ADDENDUM NUMBER TWO
TO PLANS AND SPECIFICATIONS
FOR
NEW COMPLEX FOR WASHINGTON COUNTY ROAD & BRIDGE
BRENHAM, TEXAS

October 23, 2018

PLANNORTH ARCHITECTURAL CO.

SHEET NUMBER	SHEET NAME
A2.04	TIRE & SIGN STORAGE BUILDING
DATE	
09/28/2018

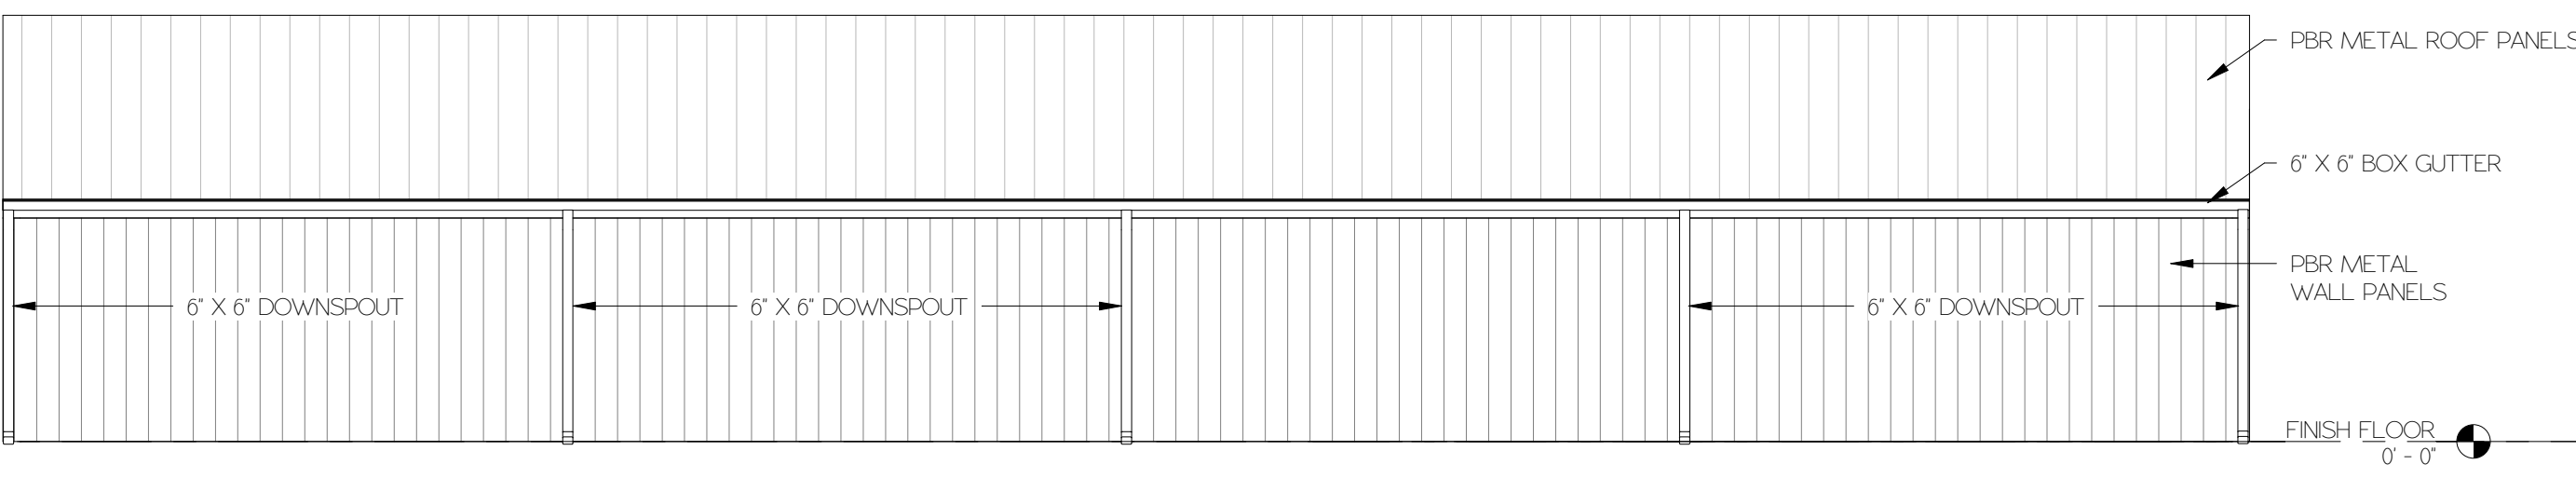
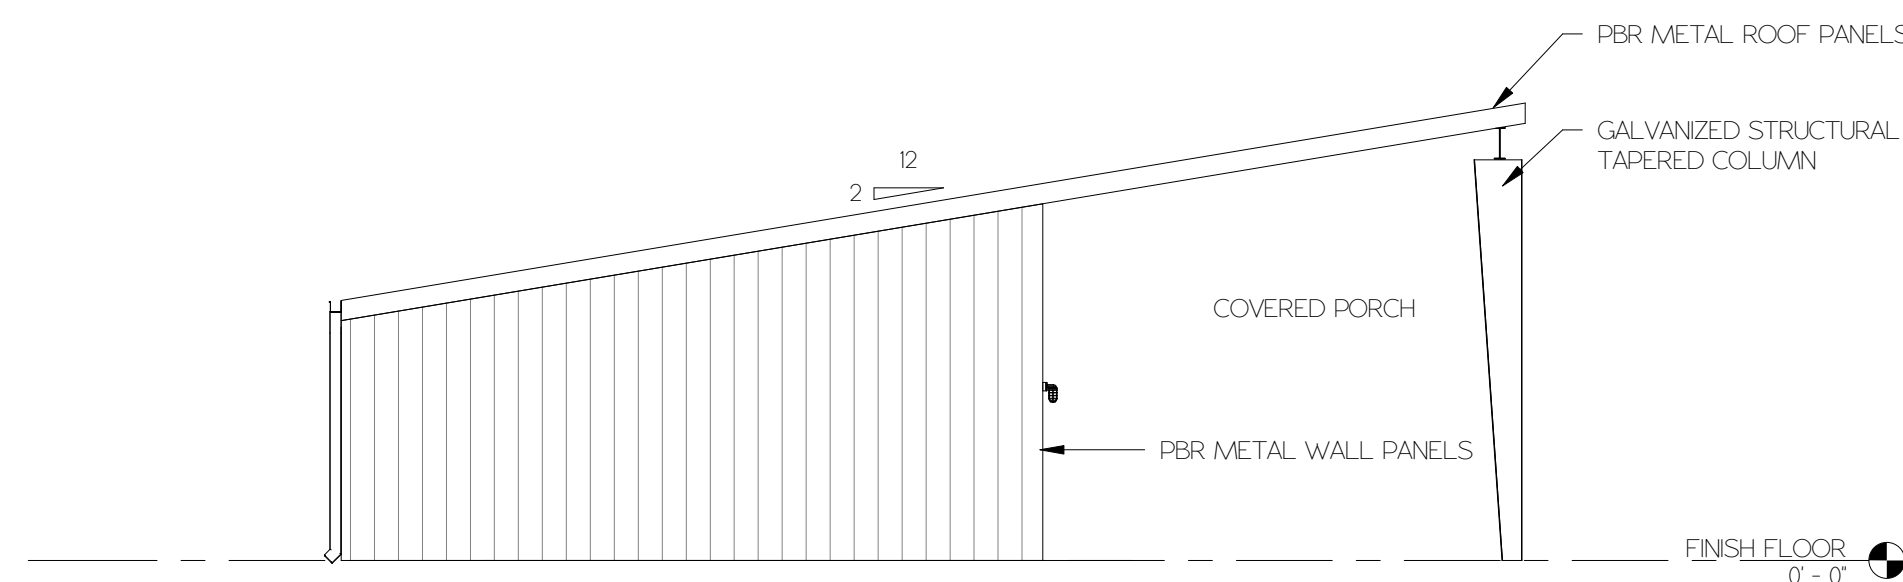
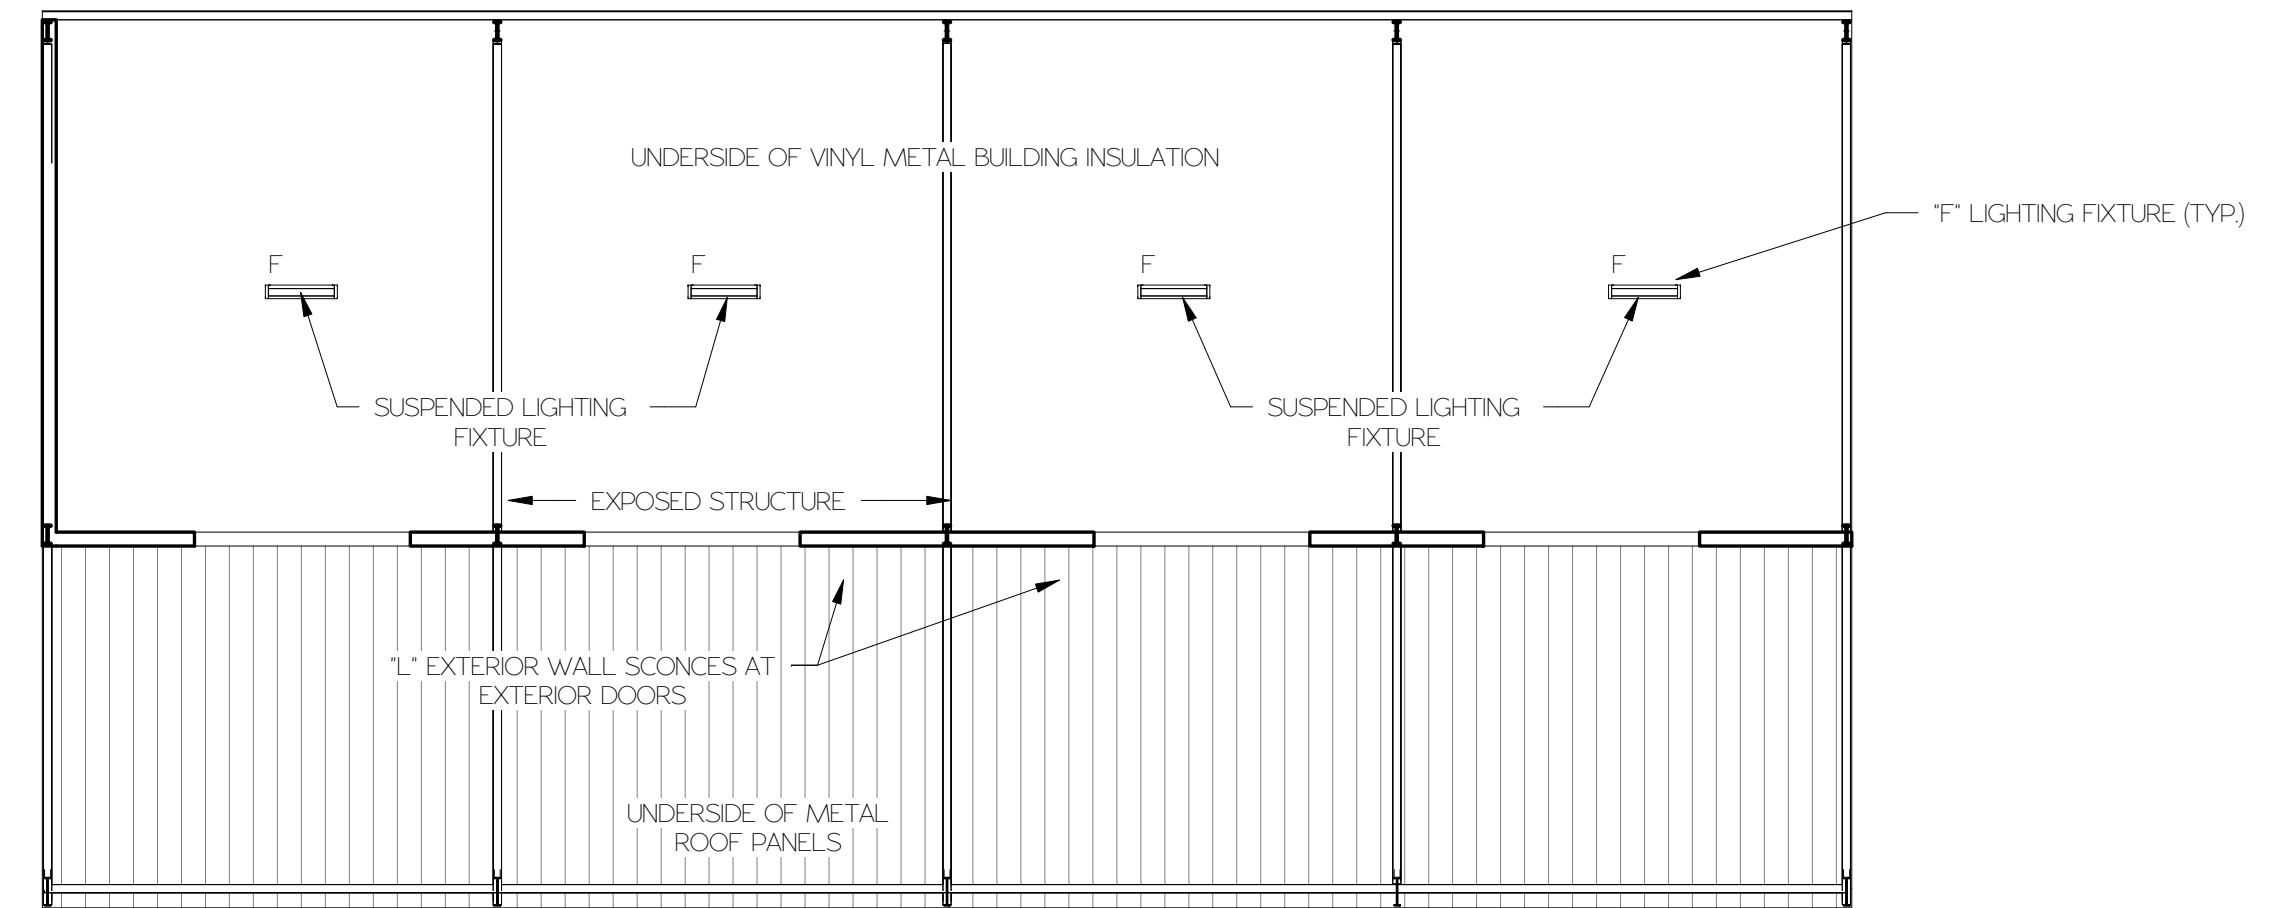
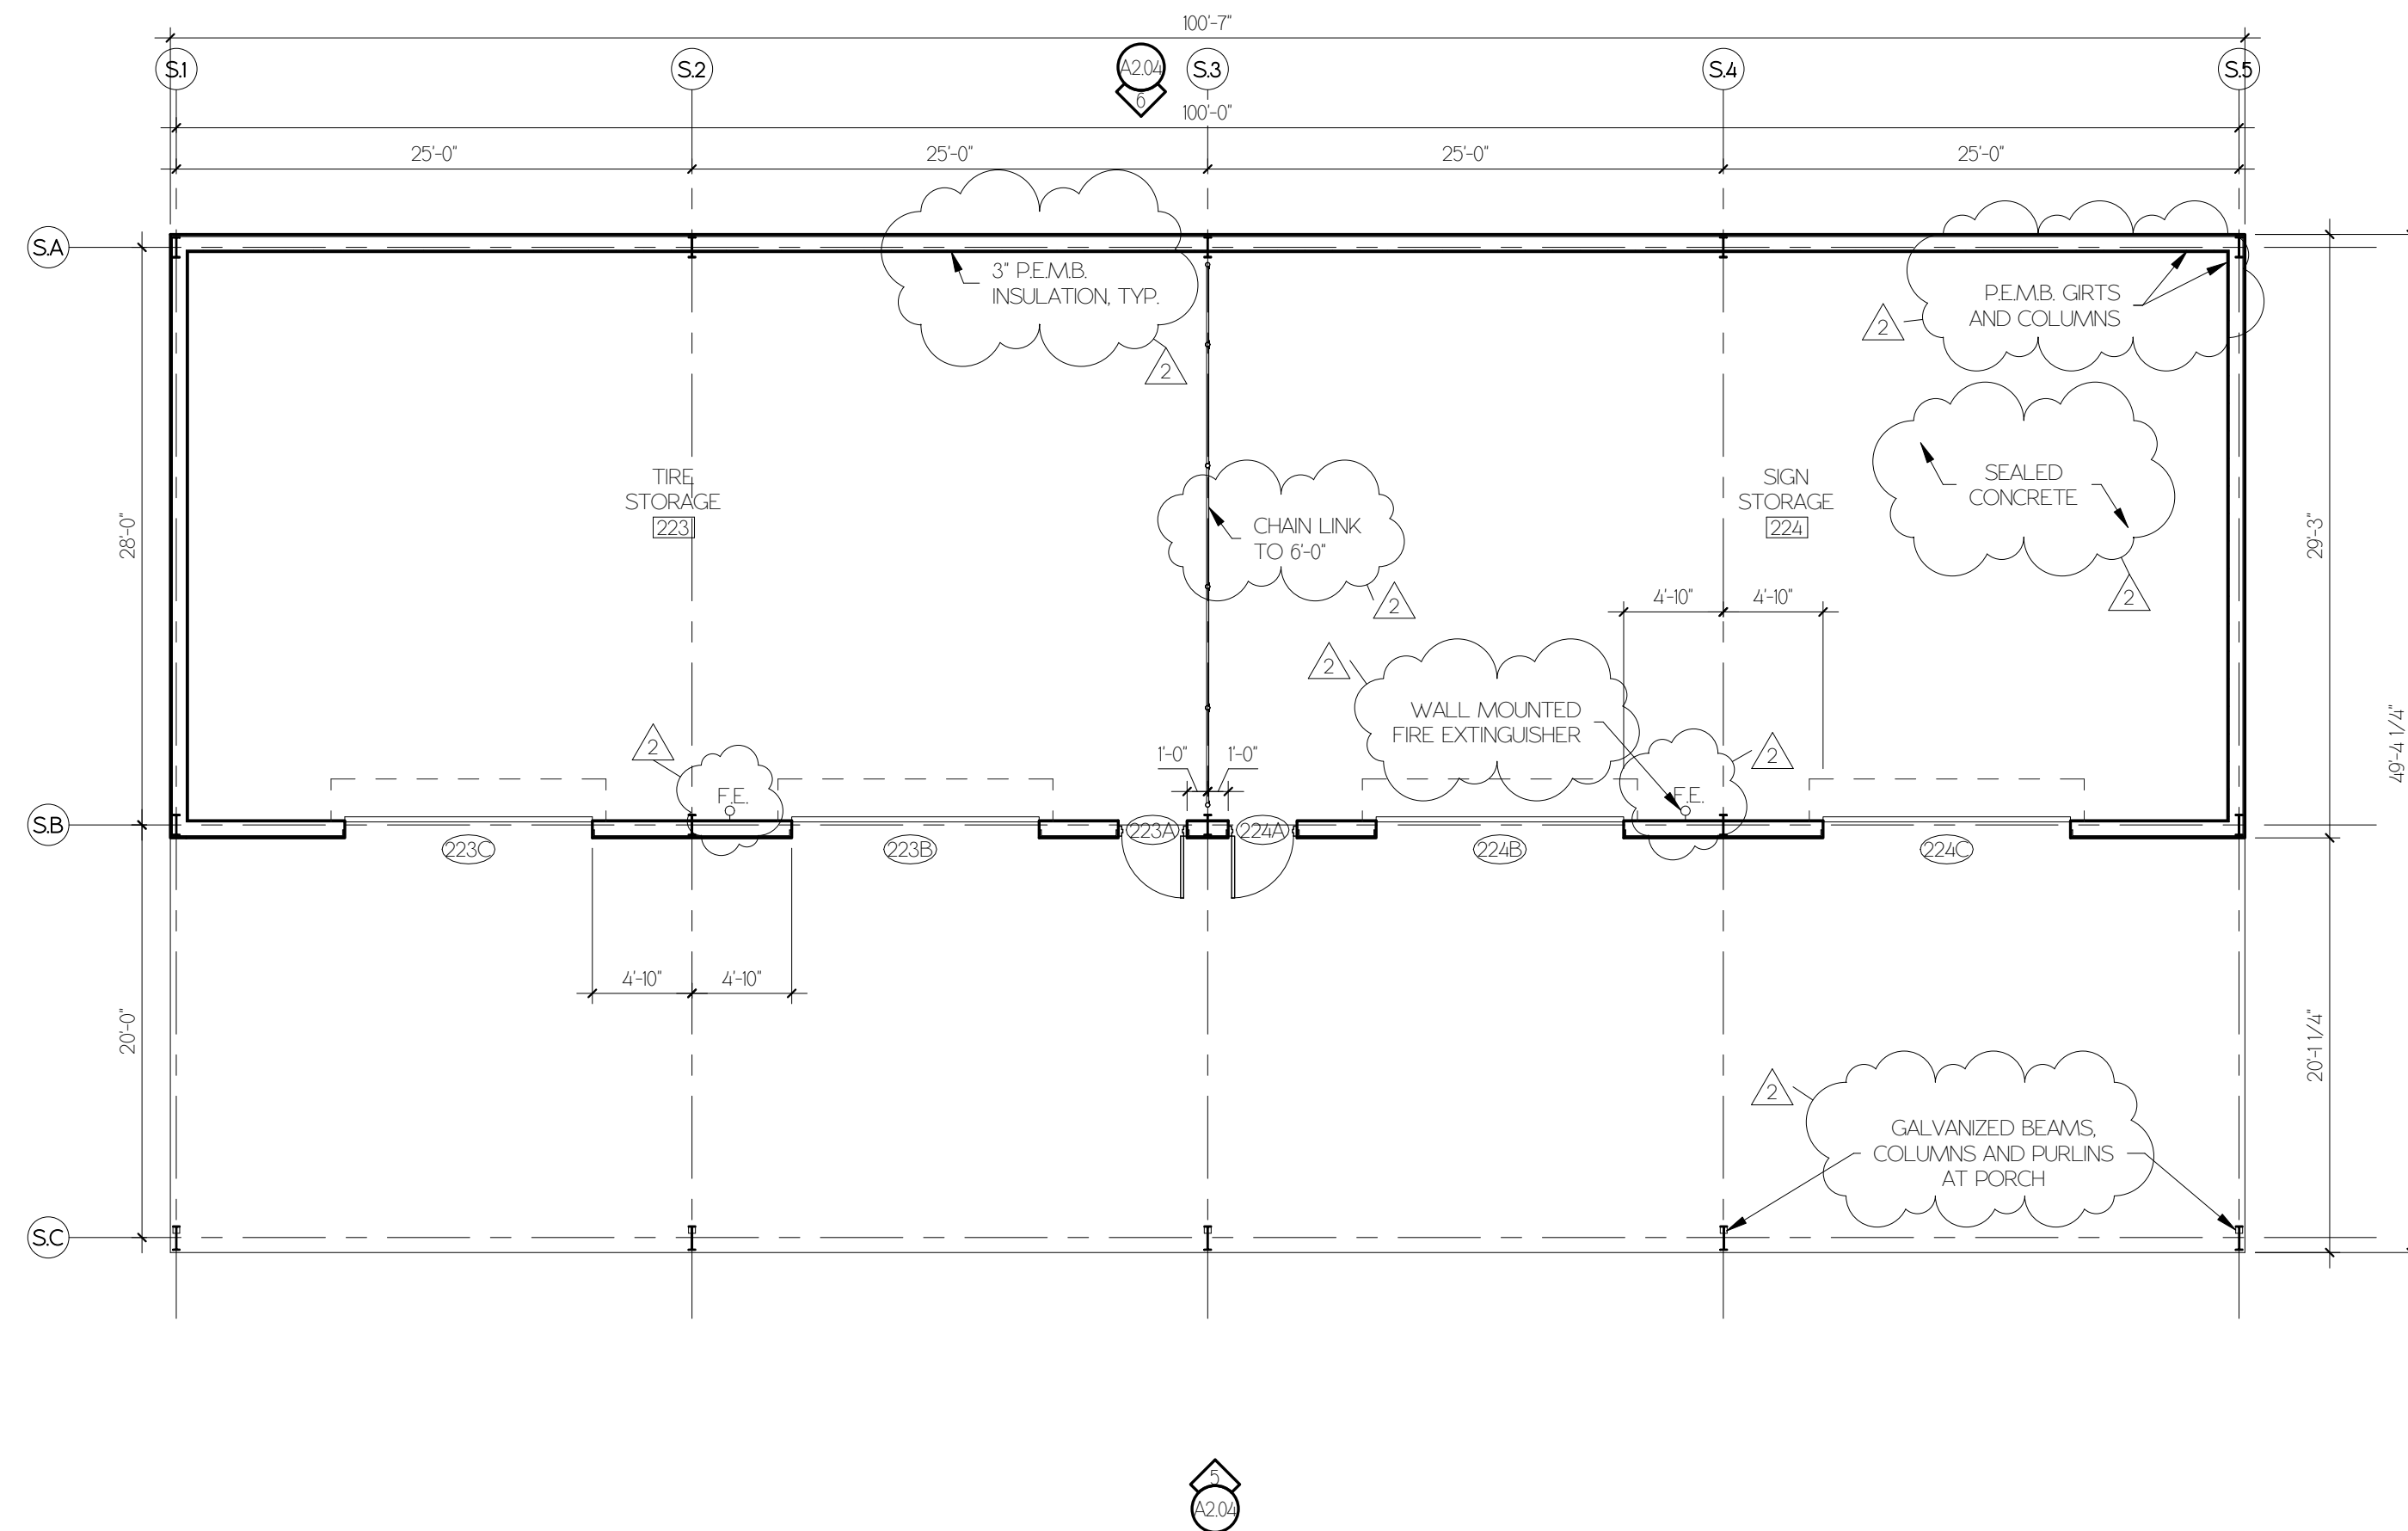
19. A2.04 TIRE & SIGN STORAGE – Add notes related to finishes as shown on the attached Sheet A2.04. Replace entire sheet A2.04.
20. A6.02 BUILDING SECTIONS – SHOP BUILDING – Building Section 1, at COVERED PORCH on right side of section, change note “6”METAL STUDS AT 16” O.C.” to read “8” WALL GIRTS”. Add NEW Wall Section 3. Replace entire sheet A6.02 BUILDING SECTIONS - SHOP BUILDING.
